**Governmental Body: Van Meter Planning and Zoning Commission Meeting**

**Date of Meeting: Monday, December 2, 2024**

## Parcels 24-108 and 24-109 Plat of Survey Review

**PLAT OF SURVEY**

# PLAT OF SURVEY

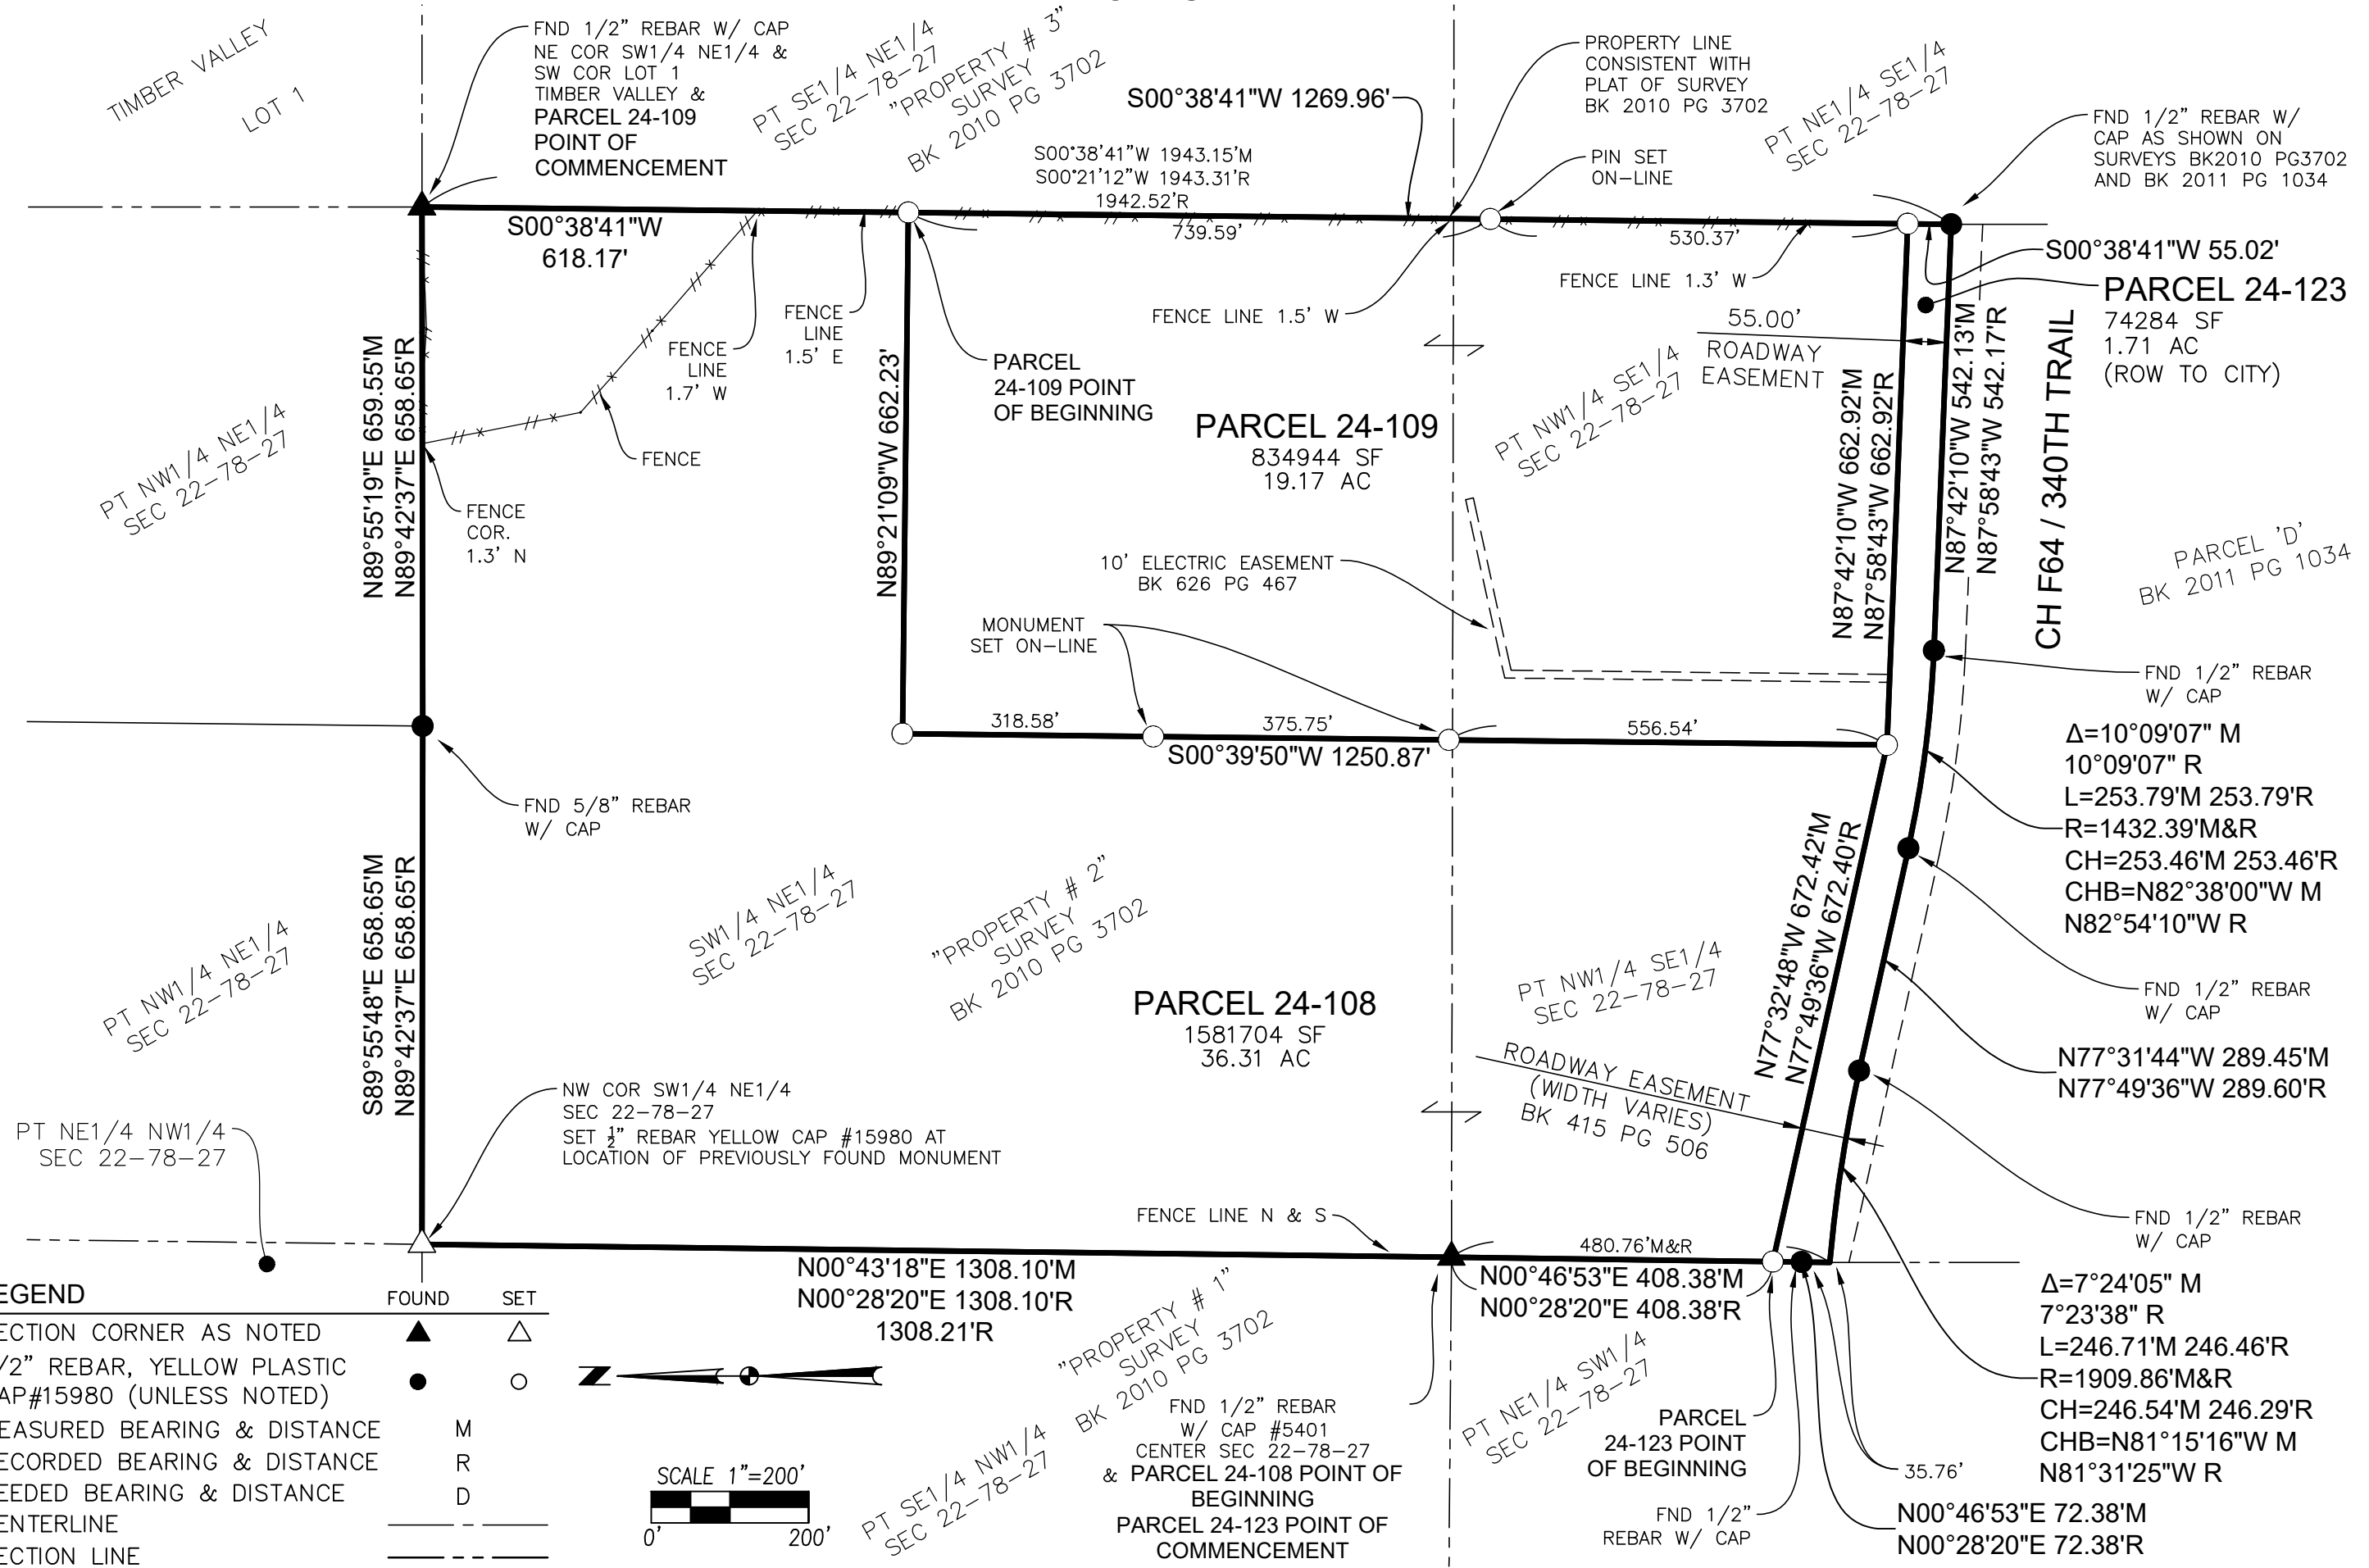
The writer has completed a review of the revised submittal of the Plat of Survey of the southwest quarter of the northeast quarter and the northwest quarter of the southeast quarter of Section 22 Township 78 North Range 27 West. The primary purpose of the Plat of Survey is to divide the existing parcel to create new Parcel 24-109 with the remainder of the existing parcel identified as Parcel 24-108.

In the writer's previous review comment it was noted under City practice the roadway easement of 340<sup>th</sup> Trail needs to be identified as a separate parcel and conveyed to the City in fee title. The revised Plat of Survey shows the creation of Parcel 24-123 that encompasses 1.71 acres of the right-of-way easement of 340<sup>th</sup> Trail. This parcel will be conveyed to the City and fee title.

The revised Plat of Survey satisfies the writer's comment relative to the original Plat of Survey. The writer has no additional comments regarding the Plat of Survey and would recommend its approval.
